ADDENDUM NO. 1  
SEWERAGE SYSTEM IMPROVEMENTS  
CONTRACT 16-01  
PEAK WASTEWATER FLOW DIVERSION  
PUMPING STATION MODIFICATIONS  
CLEVELAND UTILITIES  
CLEVELAND, TENNESSEE  
CU PROJECT NO. S2683X  
WAUFORD PROJECT NO. 4626

Date of Addendum: Wednesday, April 5, 2017

**PROPOSED SECTION B-4**  
SCALE: 3/8"=1'-0"

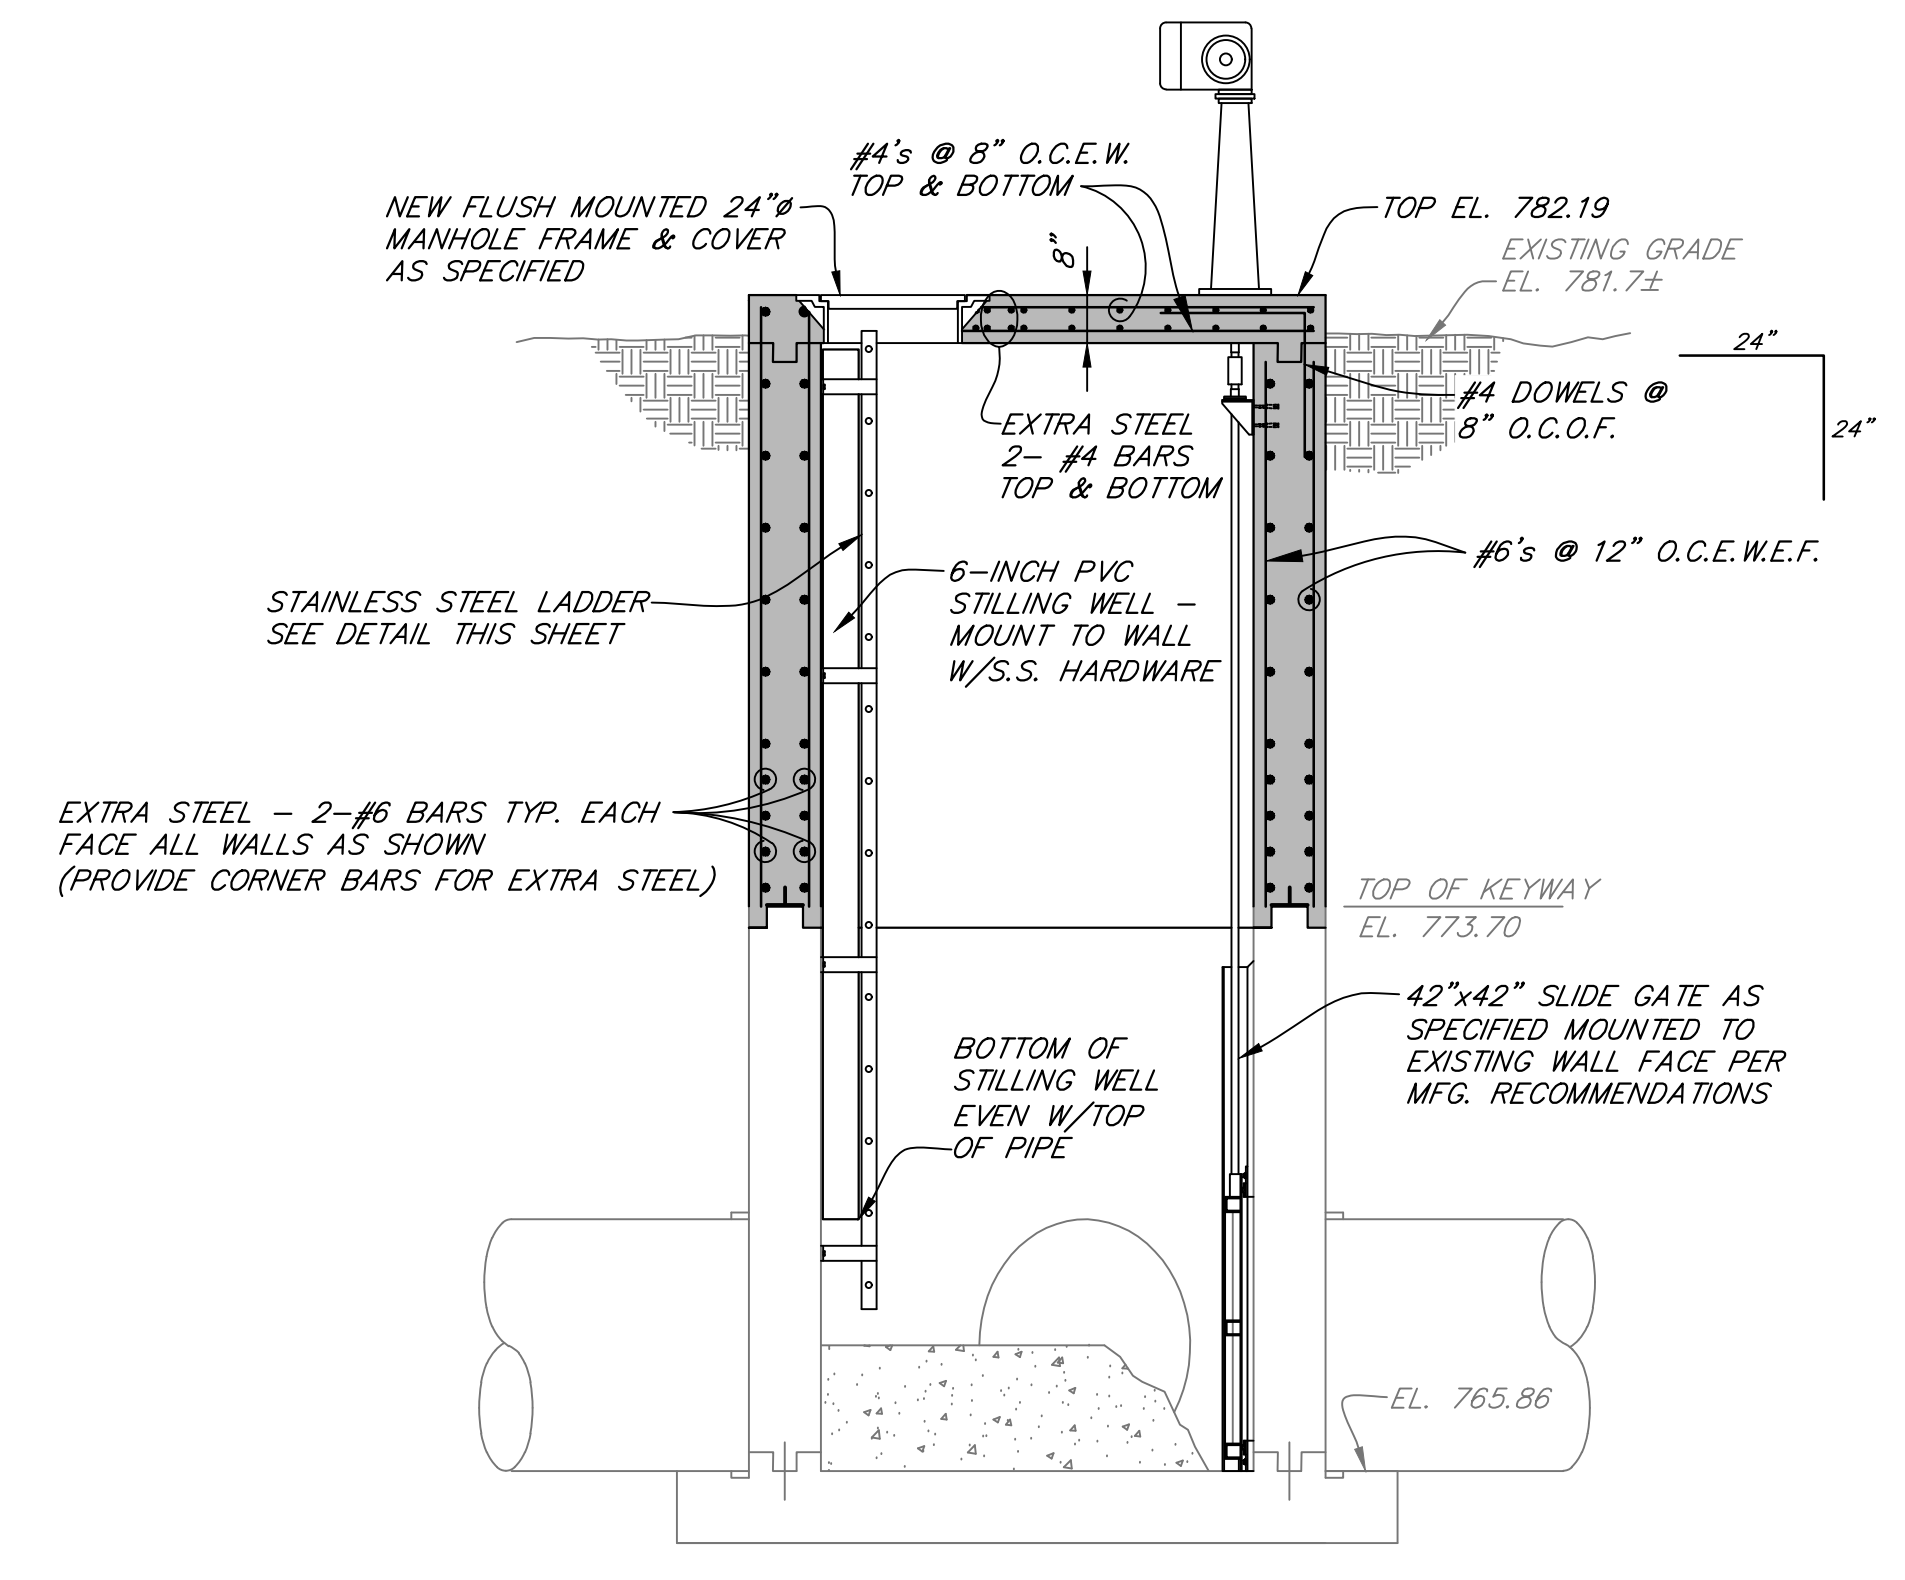
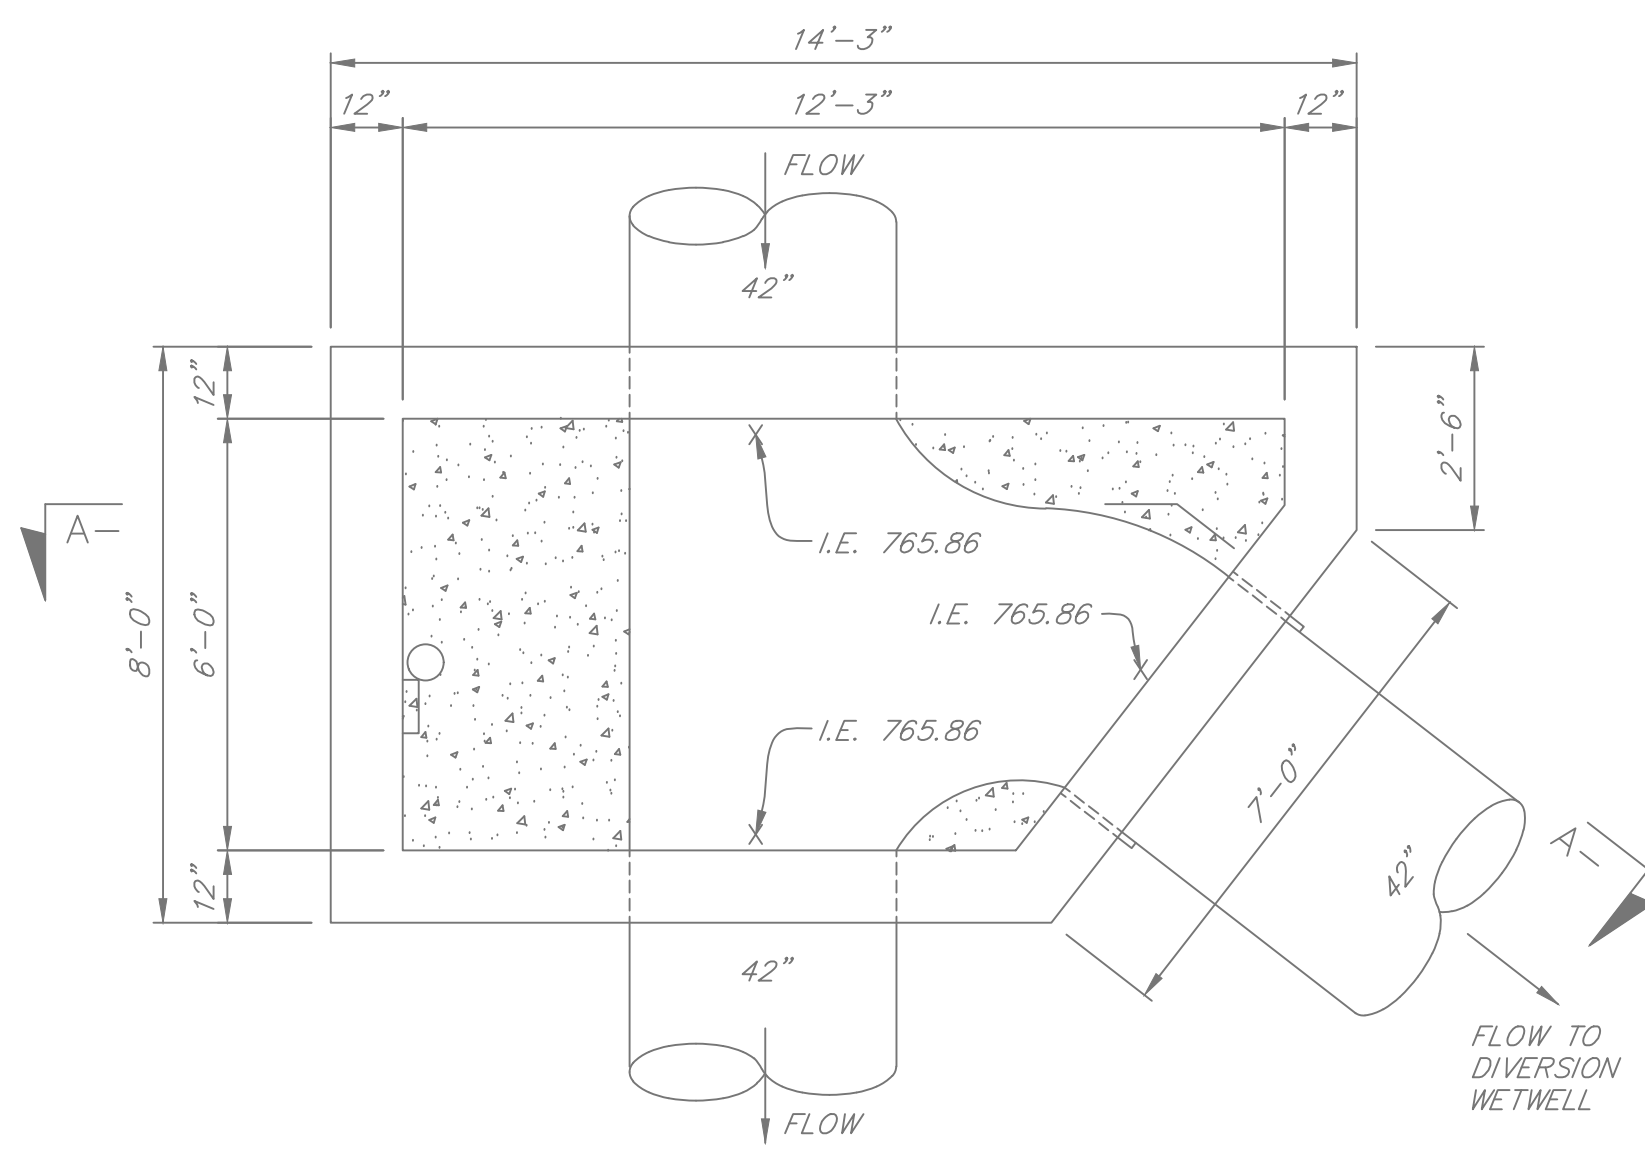
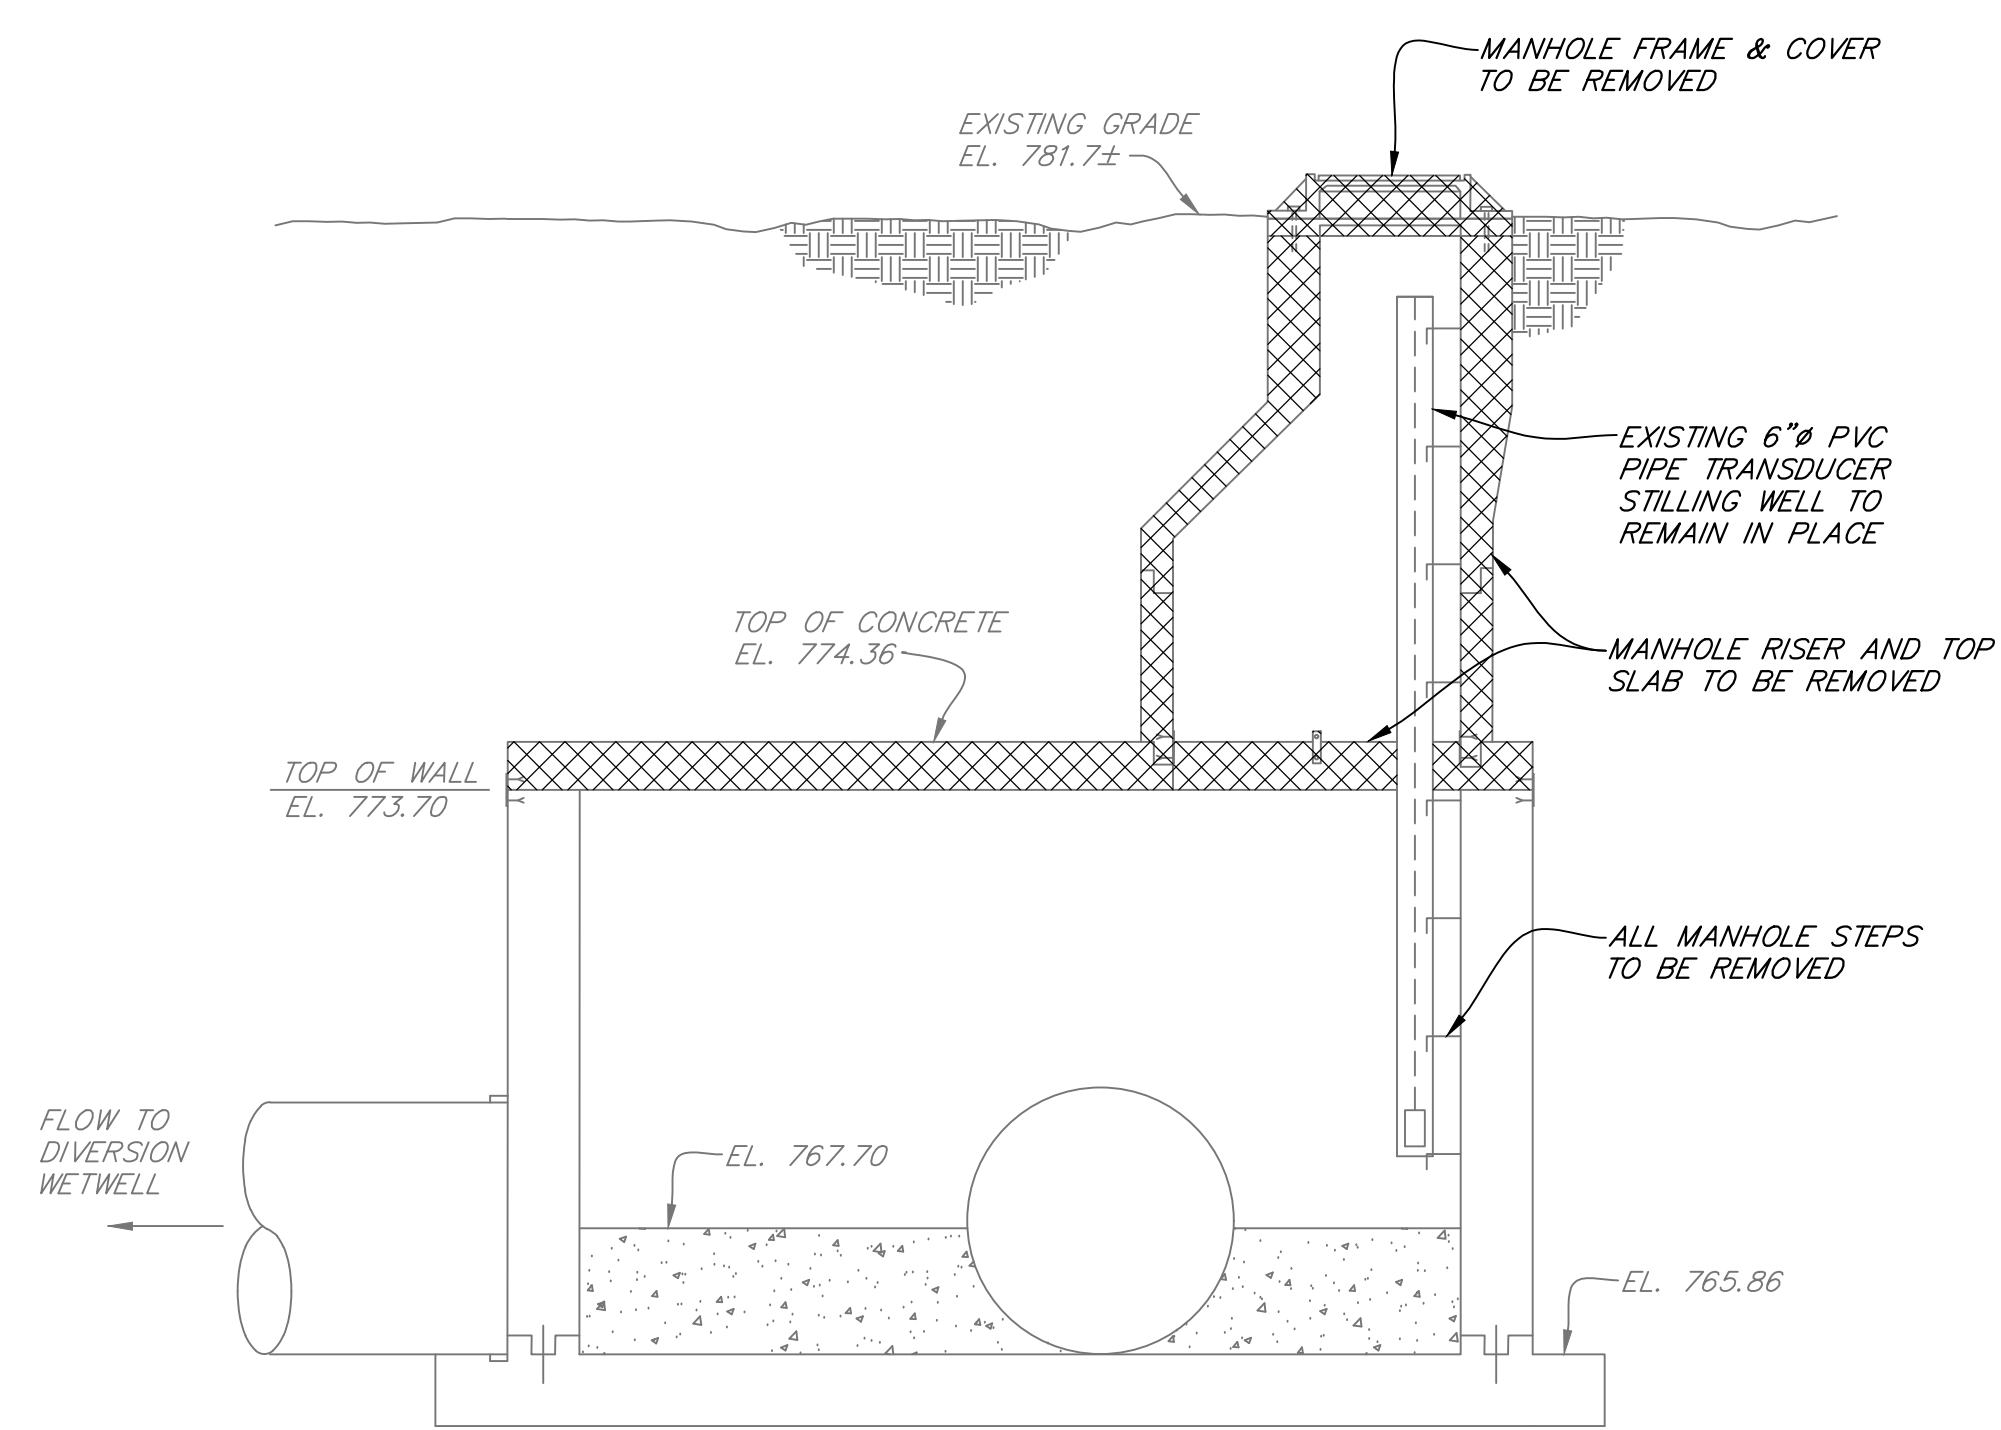
9. Plans, Sheet 4:

Revise as shown on attached Plans, Sheet 4.
